COUNCIL ASSESSMENT REPORT

Panel Reference	PPSSNH-462
Parent DA Number	DA0197/18
eMOD Number	eMOD0047/23
LGA	Ku-ring-gai
Proposed Development	Section 4.56 Modification to Land and Environment Court Approval 391613 of 2018 (DA0197/18) proposing various internal and external changes to the approved mixed-use development, including changes to signage - Heritage Item
Street Address	1 and 1A Balfour Street, Lindfield (formerly known as 376-384 Pacific Highway, 386-390 Pacific Highway and 1 Balfour Street, Lindfield)
Applicant/Owner	Knight Frank Town Planning / PPI Lindfield Developments Pty Ltd
Date of eMOD lodgement	7 February 2024
Total number of Submissions	One submission
Recommendation	Approval
Regional Significant Development (Schedule 6 of the SEPP (Planning Systems) 2021	A Section 4.56 modification application to a development with a capital investment value of more than \$30 million.
List of all relevant s4.15(1)(a) matters	<ul style="list-style-type: none"> • Environmental Planning and Assessment Regulation 2021 • State Environmental Planning Policy (Resilience and Hazards) 2021 • State Environmental Planning Policy (Transport and Infrastructure) 2021 • State Environmental Plan

Figure 3: Height Blanket Diagram and Schedule of Amendment at roof top level

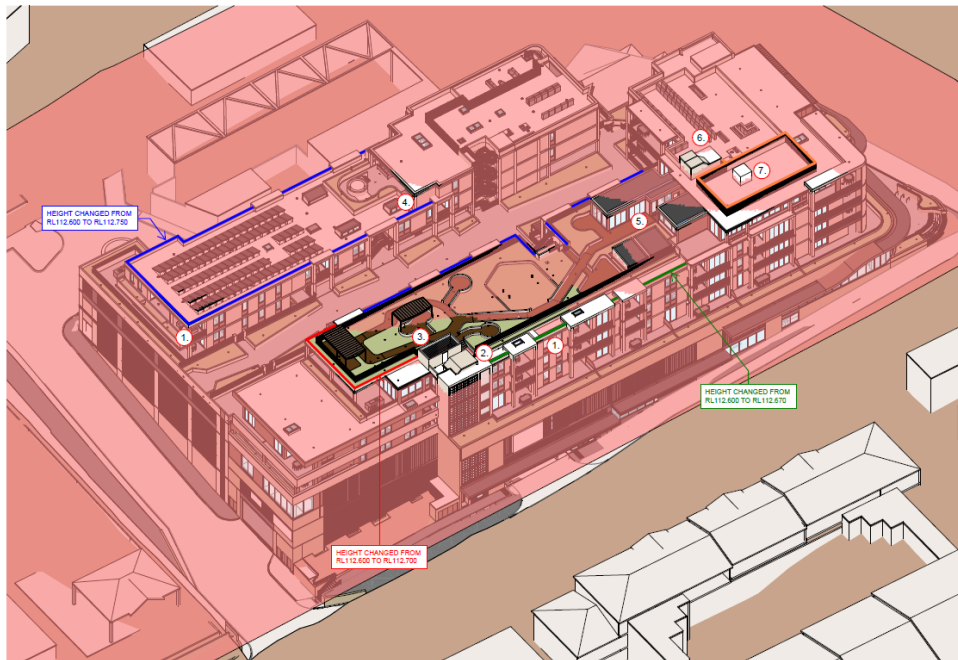
The greatest building height variations are confined to service elements of the development, specifically Coles smoke exhaust enclosure (2.35m variation), roof to fire stair 04 (2.25m variation) and plant enclosure for chiller equipment (1.98m variation). These elements are necessary for the proposed uses within the development and are generally set back from the edges of the building.

These elements will not result in any additional view, solar access, visual amenity or privacy impacts (beyond the approved development), nor materially add to the bulk or scale at the top of the building when viewed from the public domain and adjoining properties.
